ADDENDUM #5

Reference: Noorda Black Box Theater Addition and Remodel
Utah Valley University – Orem, Utah
DFCM Project No. 08017790

ADDENDUM - 5

Project: UVU Noorda Theater
DFCM Project Number: 08017790
Axis Project Number: 0804
To: Mike Ambre
From: Axis Architects
Date: August 16, 2008

MODIFIED PORTION OF AE001	ADD 3.03
---------------------------	----------

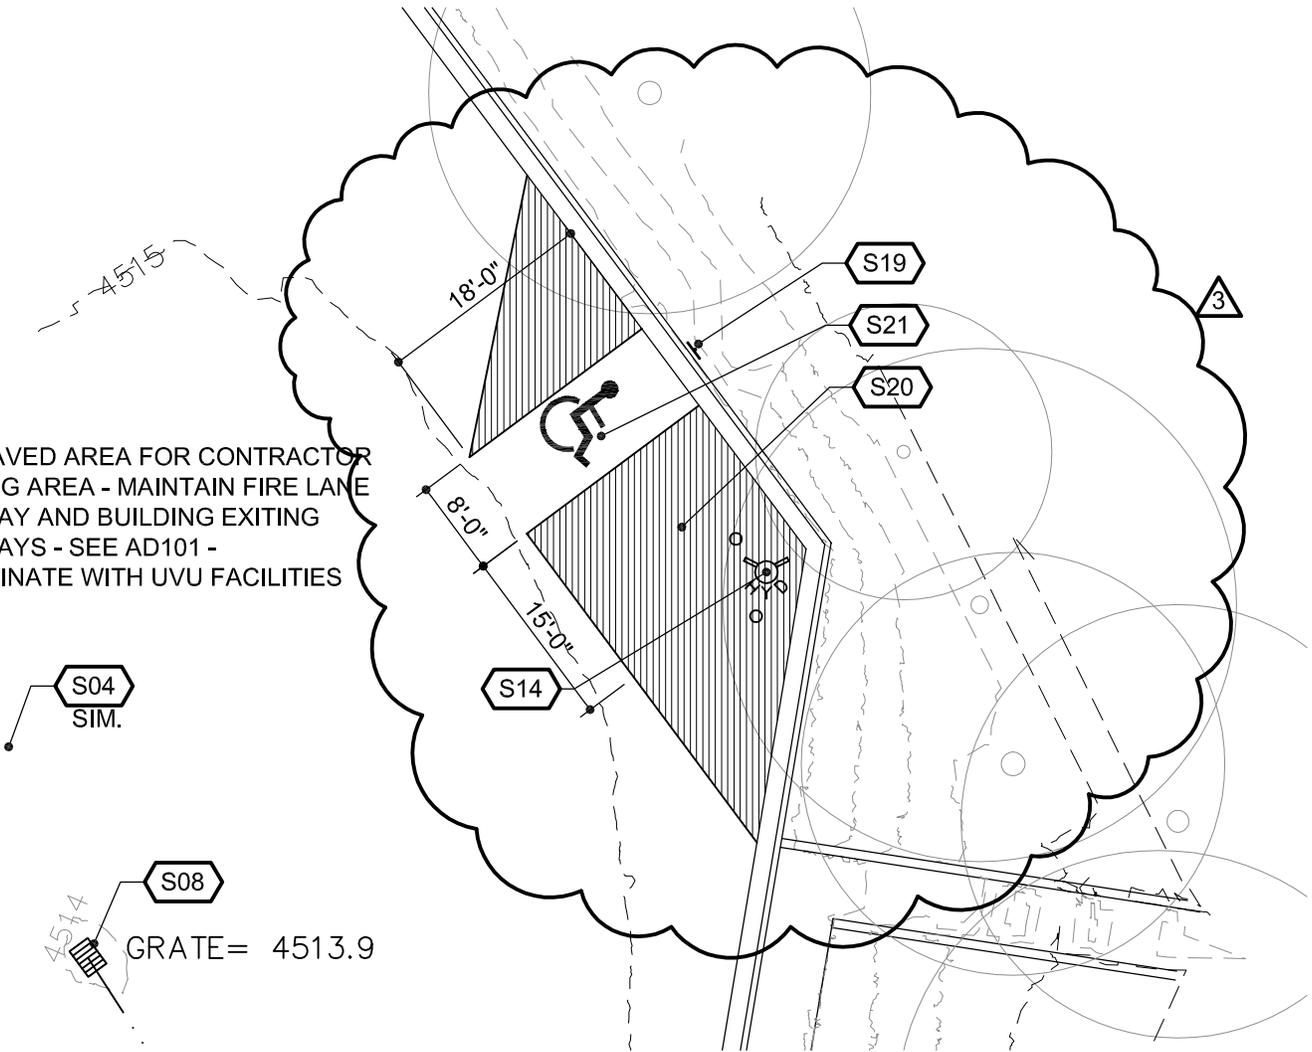
- See attached detail ADD 3.03 for added and relocated bollards.

MODIFIED PORTION OF AE001 ADD 3.04

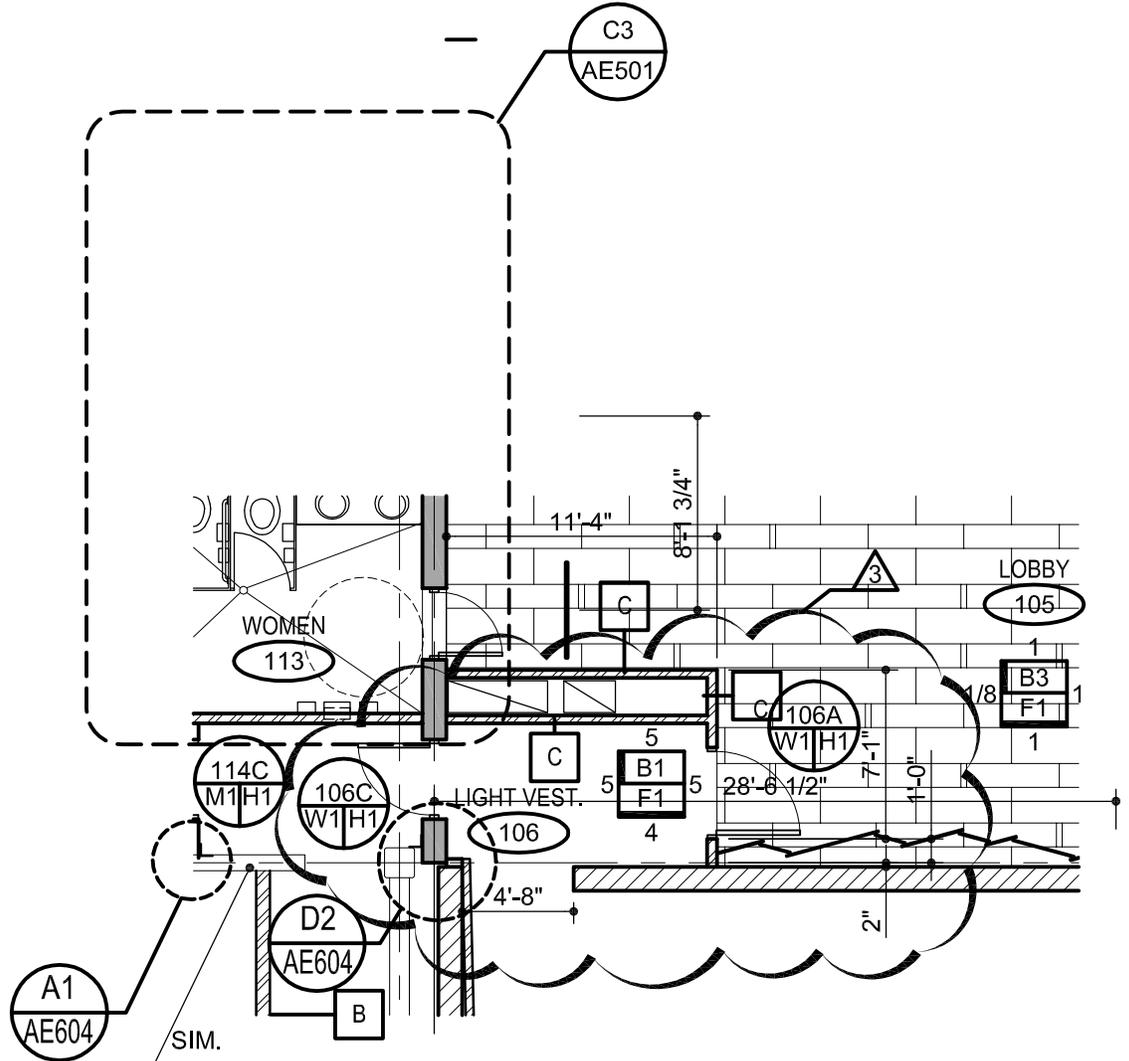
- See attached detail ADD 3.04 for added and stripping and ADA sign.

- In keynote legend, add keynote S19 to read " Add ADA sign w/ van access. See detail B6/AE607. "

- In keynote legend, add keynote S20 to read " Paint stripes"

- In keynote legend, add keynote S21 to read " Painted ADA symbol".

MODIFIED PORTION OF AE101	ADD 3.05
---------------------------	----------

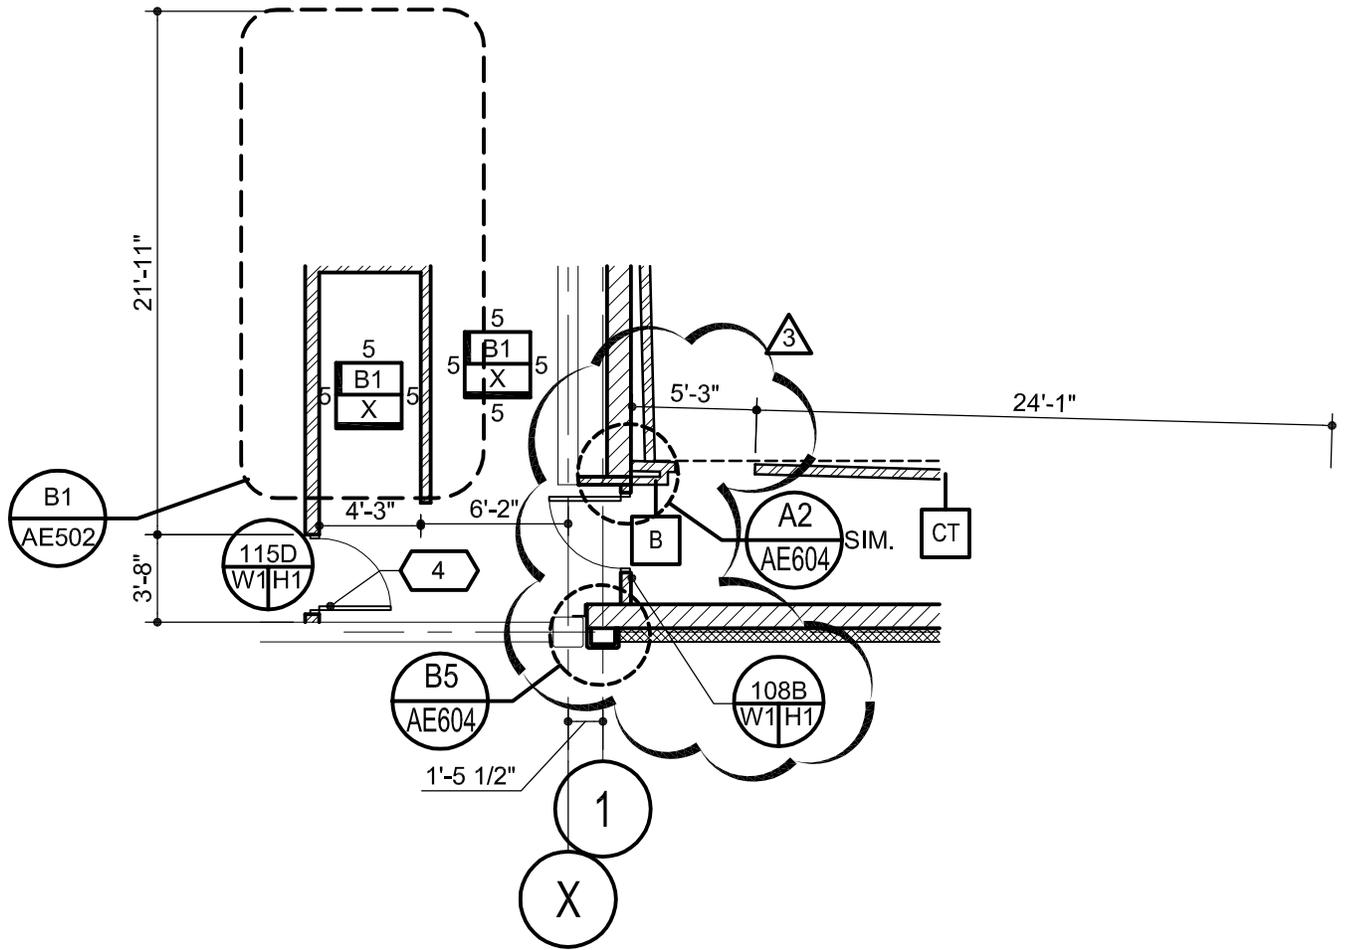
- Add door symbol "106C " to the west door of light vestibule 106 and updated dimensions. See attached detail ADD 3.05
 - Switch swing of door 108A. See attached detail ADD 3.06

MODIFIED PORTION OF AE101	ADD 3.07
---------------------------	----------

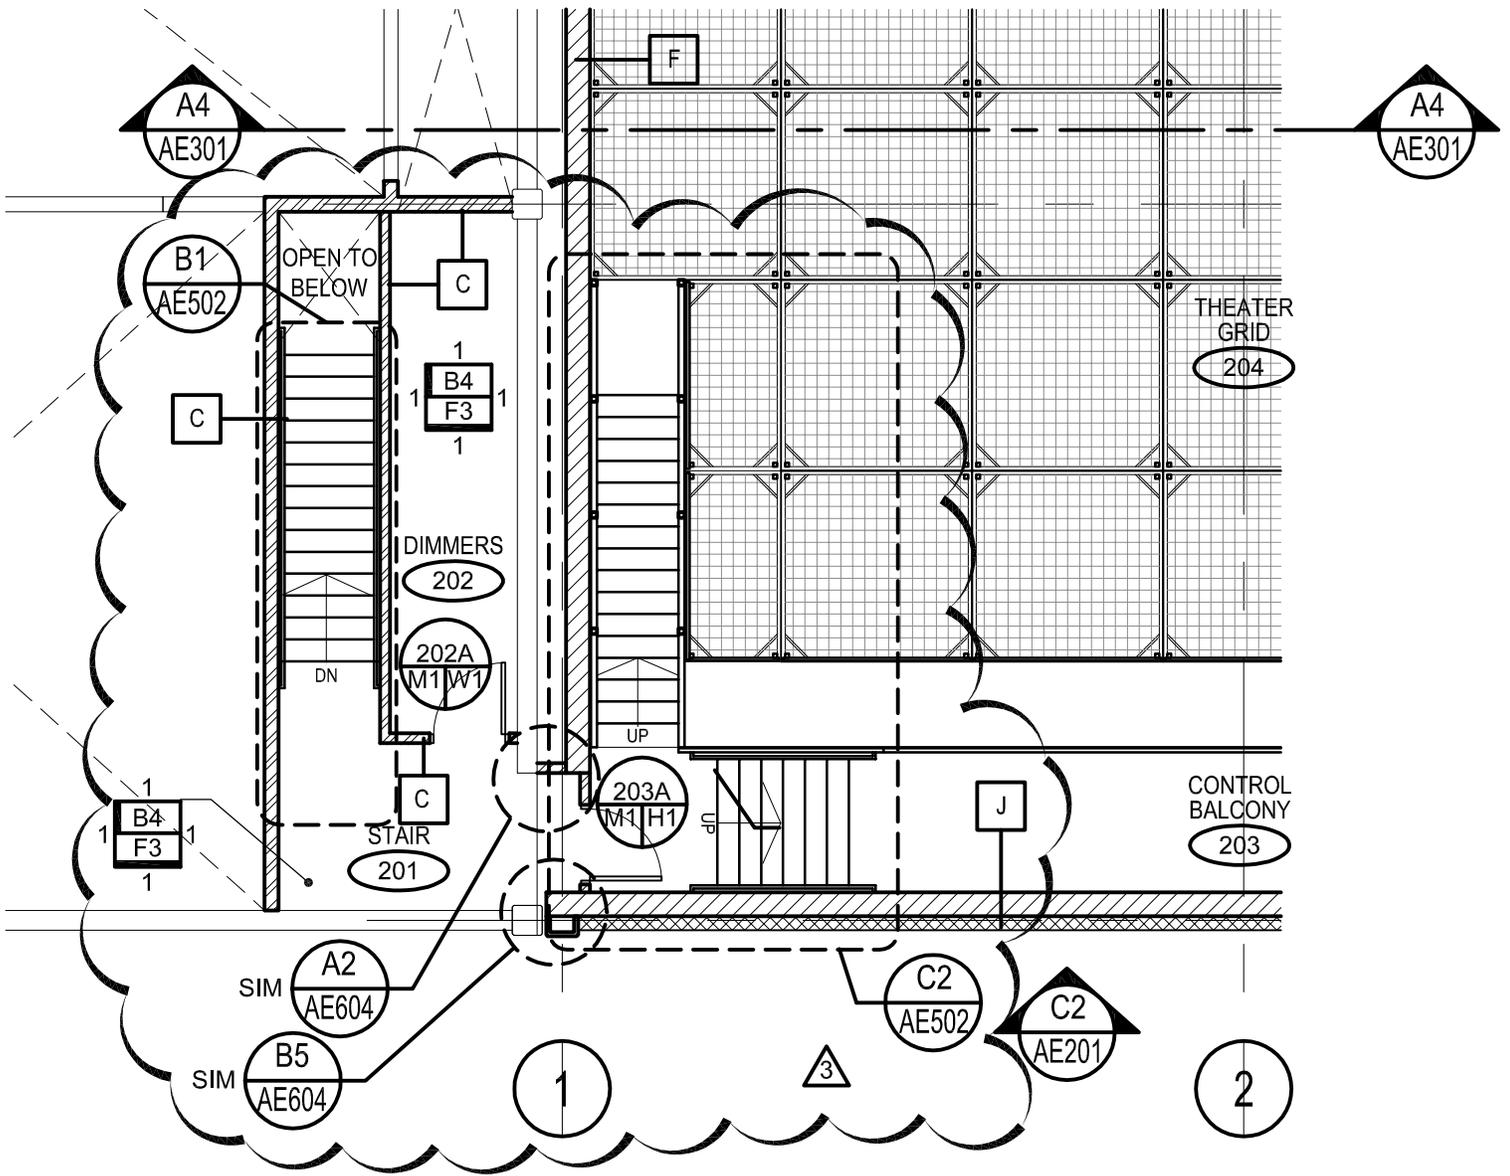
- Switch swing of door 108B. See attached detail ADD 3.07
- Sheet AE102:** See revised stair layout and door swing of 203A. See detail ADD 3.08.
- Sheet AE111:** White Box Alternate: the ceiling of White Box 131 shall be the existing lay-in ceiling re-configured for the new layout with lighting as shown by Electrical (see this Addendum). The ceiling of White Box Audience 132 shall be a new lay-in ceiling at 10'-0" above finish floor with lighting as shown by Electrical (see this Addendum). The ceiling of White Box Office 133 shall be a new lay-in ceiling at 10'-0" above finish floor with lighting as shown by Electrical (see this Addendum).

MODIFIED PORTION OF AE122 ADD 3.09

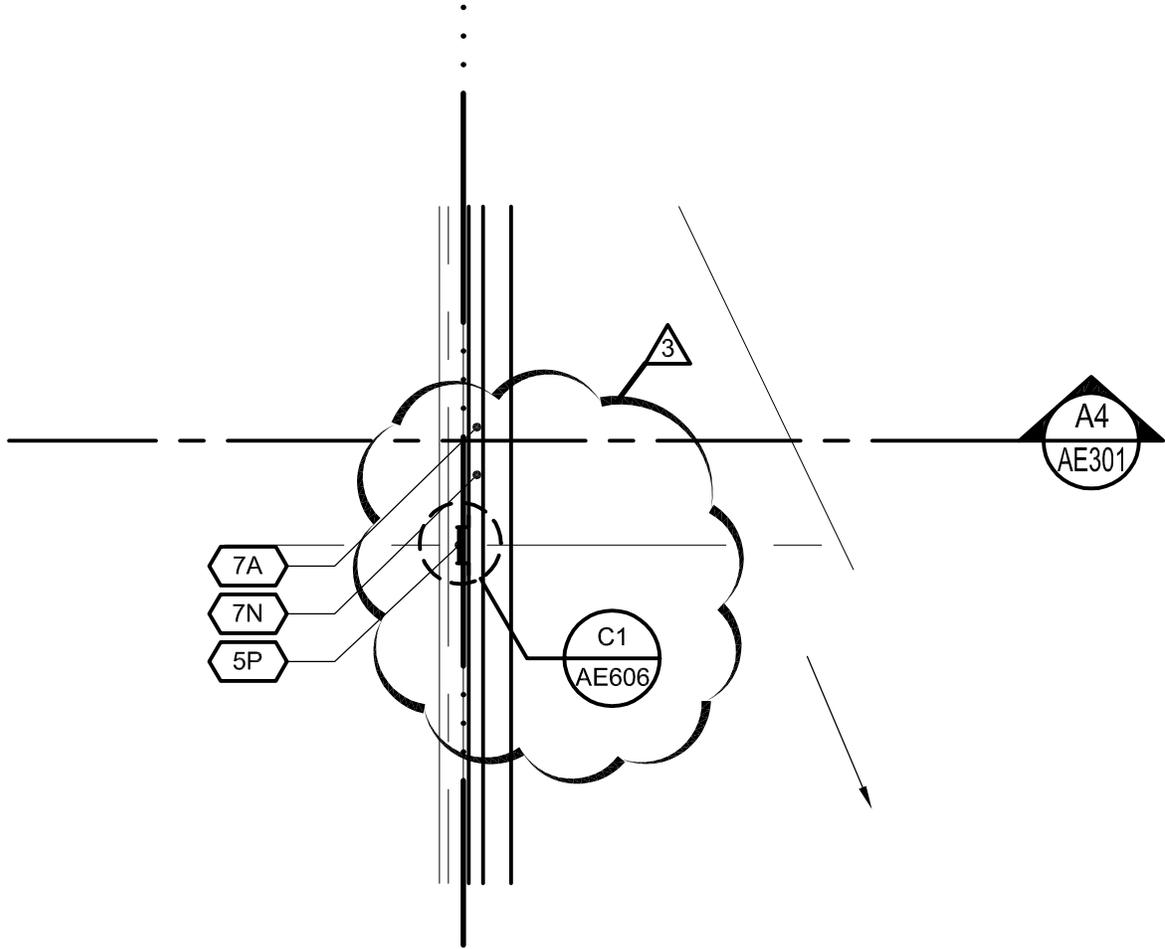
- Sheet AE122:**- Revise deck bearing heights and added roof ladders. See attached detail ADD 3.09
 - Add roof ladder as indicated. See attached detail ADD 3.10

MODIFIED PORTION OF AE501

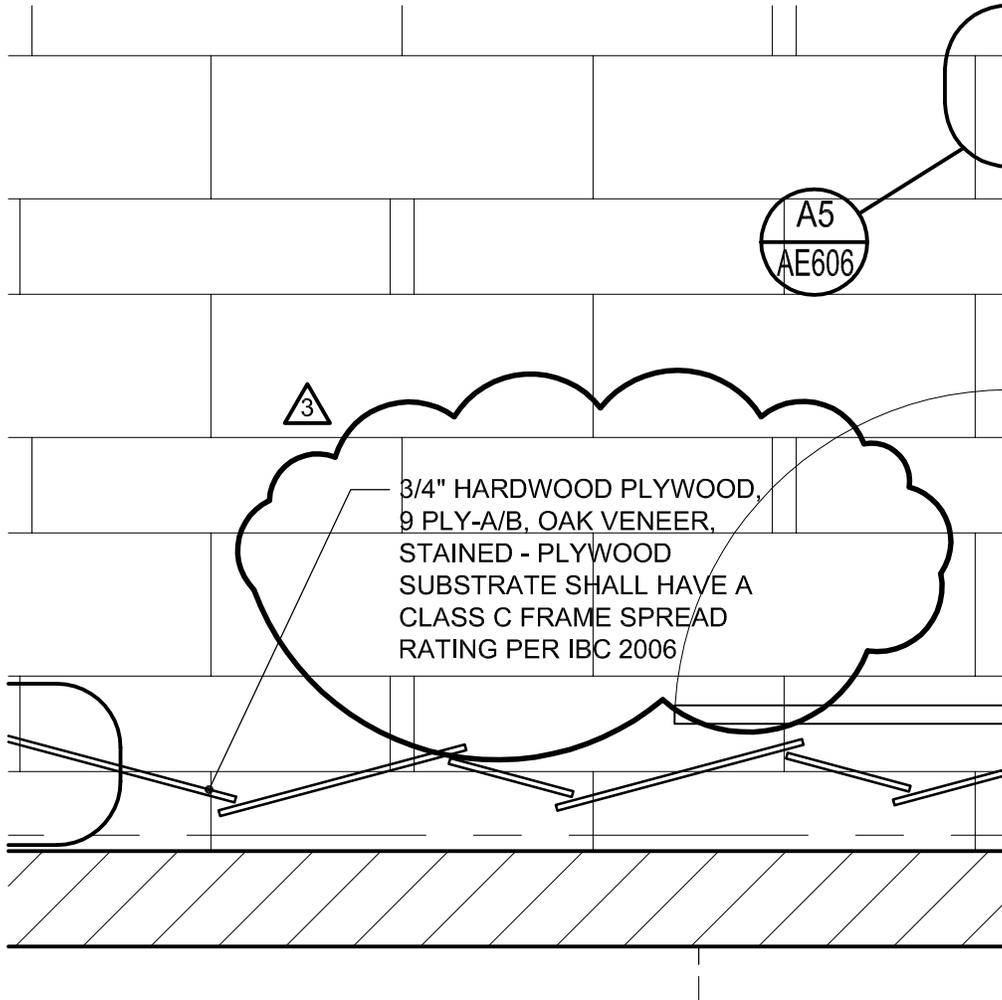
- Sheet AE500:** See additional sheet attached.
- Sheet AE501:** See attached detail ADD 3.11 for changes to cabinets. Also see detail references.
- Sheet AE502:** See additional sheet attached.

MODIFIED PORTION OF AE606	ADD 3.12
---------------------------	----------

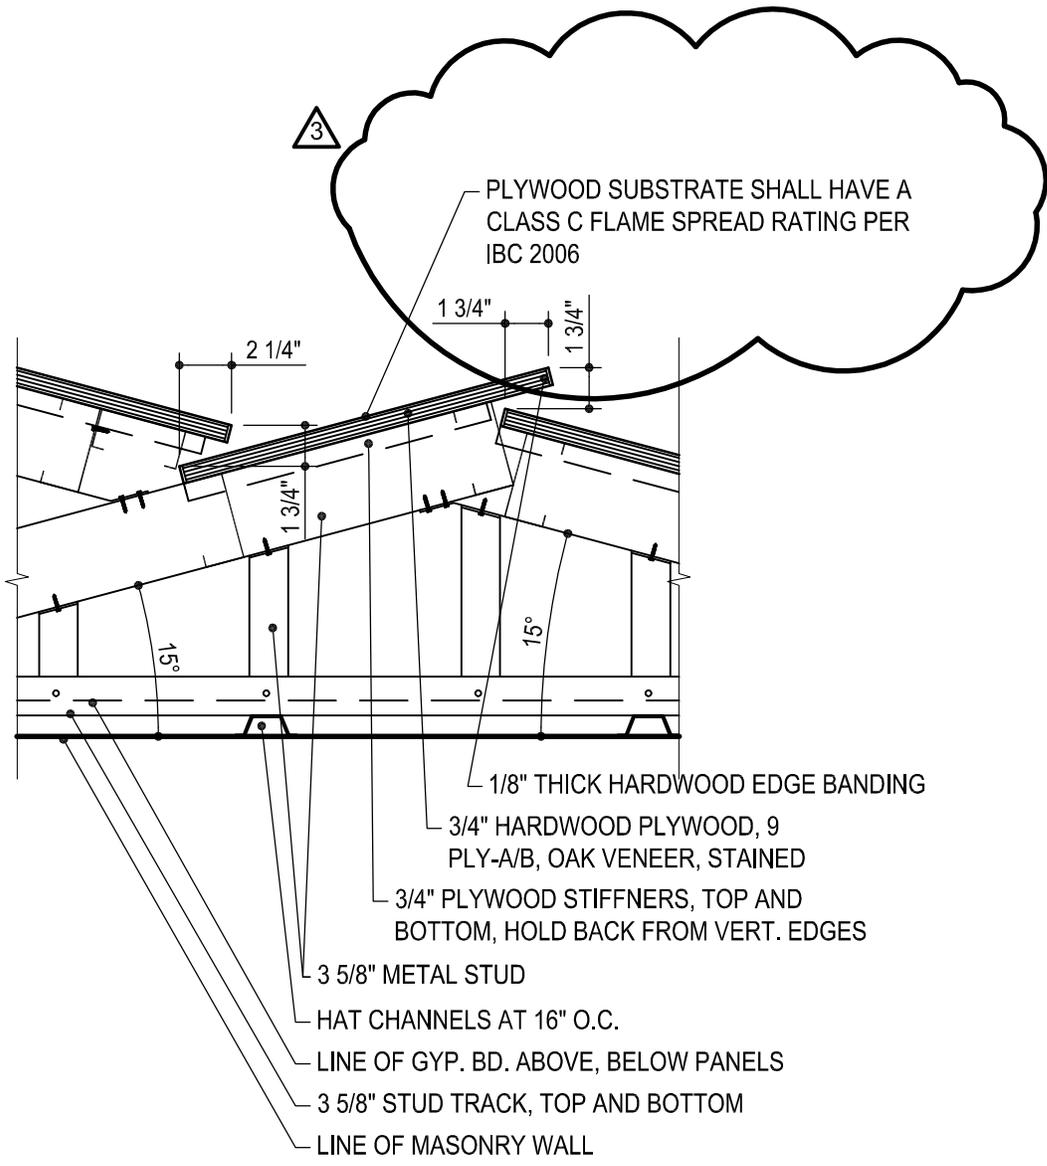
- Sheet AE605:** Details C2 and C3: Change dimension of guard to read 3'-6" in lieu of 36".
- Sheet AE606:** - See attached detail ADD 3.12 for updated note.

MODIFIED PORTION OF AE606	ADD 3.13
---------------------------	----------

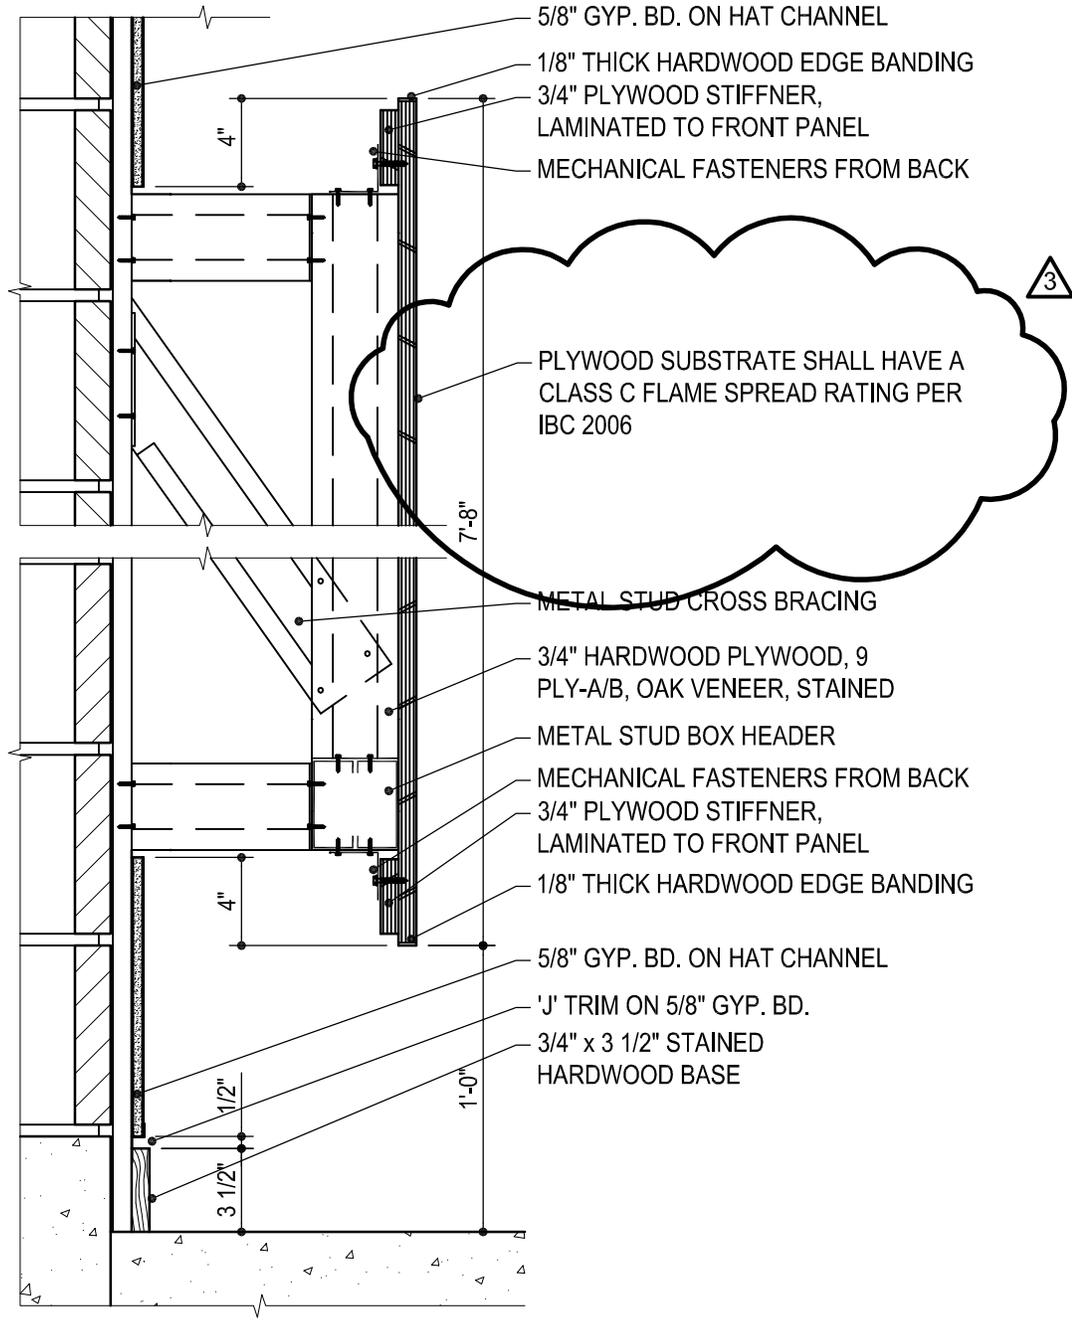
- See attached detail ADD 3.13 for updated note.
 - See attached detail ADD 3.14 for updated note.
- Sheet AE607:** See additional sheet attached.
